Access Compliance Report

Public Rights-of-Way

Intersection ID: 44417	Main Street: MARVIN_RD	Cross Street: ARDREY_KELL_RD	Location: W
ADA ID: 4D1ACA1469D3	Ramp Type: Perp	Initial Pass/Fail: Pass	Overall Compliance: No
			Severity Score: 7.75

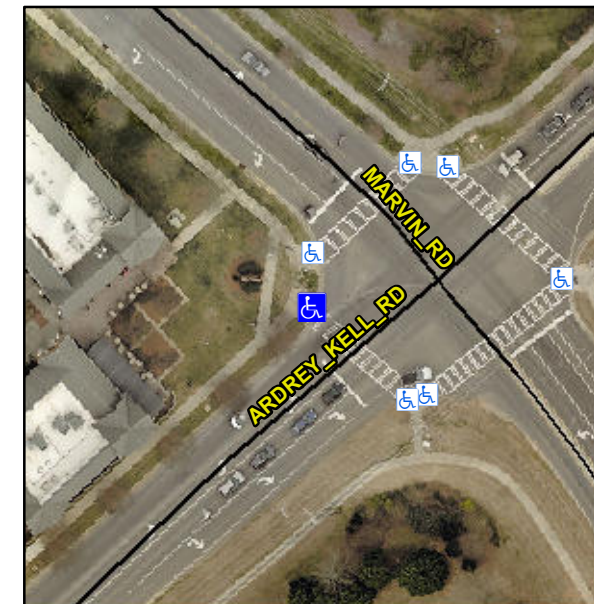
**R304.2.2-Perp, R304.3.2-Para,
R304.5.3, R207.1, R302.7.2**

Compliance	Description	Data	Compliance	Description	Data
N/A	Ramp Length (in)	96.0	Yes	Ramp Slope (%)	6.8
Yes	Ramp Width (in)	48.0	Yes	Ramp XSlope (%)	2.9
N/A	Flare Type LT	Sloped	N/A	Flare Type RT	N/A
N/A	Flare Slope LT (%)	9.0	N/A	Flare Slope RT (%)	2.0
N/A	Flare Traversable LT?	Yes	N/A	Flare Traversable RT?	No
Yes	Landing Length (in)	67.0	Yes	DWS Provided?	Yes
Yes	Landing Width (in)	48.0	Yes	DWS Contrast?	Yes
No	Landing Slope (%)	4.1	Yes	DWS Length (in)	24.5
No	Landing X Slope (%)	4.5	Yes	DWS Full Width?	Yes
N/A	Landing Curb? (Y/N)	No	Yes	DWS Offset (in)	1.0
N/A	Shared Landing?	No			
Yes	Gutter Ponding?	No	Yes	Gutter Slope (%)	2.3
No	Gutter Lip Ht (in)	0.5	Yes	Gutter X Slope (%)	2.8
N/A	Painted X Walk1?	Yes	N/A	Painted X Walk2?	N/A
	X Walk 1 Direction	To SE		X Walk 2 Direction	N/A
N/A	X Walk 1 Width (in)	111.0	N/A	X Walk 2 Width (in)	N/A
	X Walk 1 Slope (%)	1.3		X Walk 2 Slope (%)	N/A
	X Walk 1 X Slope (%)	3.4		X Walk 2 X Slope (%)	N/A

**Remove & Replace Landing.
Restripe Crosswalk. Grind Gutter
Lip.**
